**Report: FINAL TAB REPORT
Function: Test, Adjust, & Balance
Date: 10/11/2022**

**PROJECT
10-03 FREDDY'S HAMPTON, VA**

Issue Name : RTU-1 Condensate is not installed-W.I.P

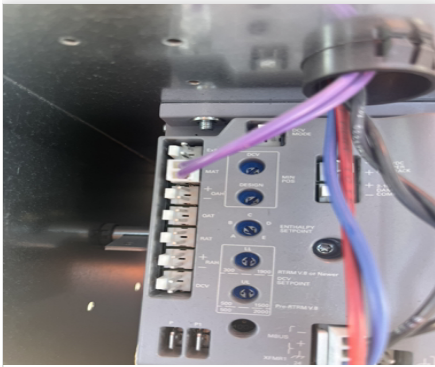
Description : RTU-1 condensate line is not installed .

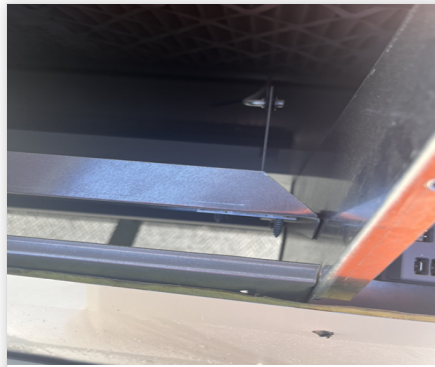
Issue Name : RTU-1 Economizer not functional
Description : Unable to set RTU-1 damper position despite the economizer receiving power. Tried moving damper to closed position the damper did not move.
Created By : National TAB **Assigned To :** National TAB - Will Turnbough
Status : Open
Originated Date : 10/06/2022 - David Annan - National TAB

Issue Name : RTU-1 Low flow

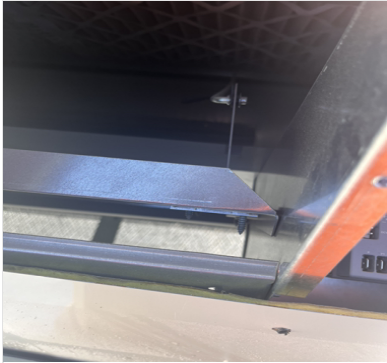
Description : RTU-1 total flow is about 80% of design. Motor sheave is already at 1 turn out (B belt).

- Result of the low flow could be from the return or OA dampers not opening up to provide more airflow.

Issue Name : RTU-1 Smoke detector not installed-W.I.P

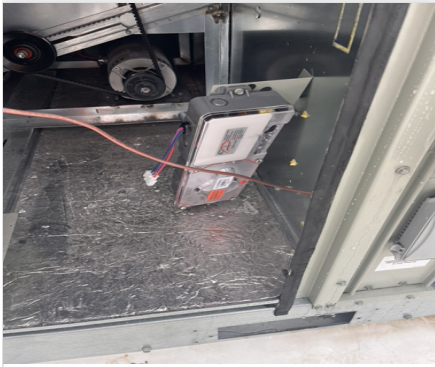
Description : RTU-1 smoke detector is not installed.
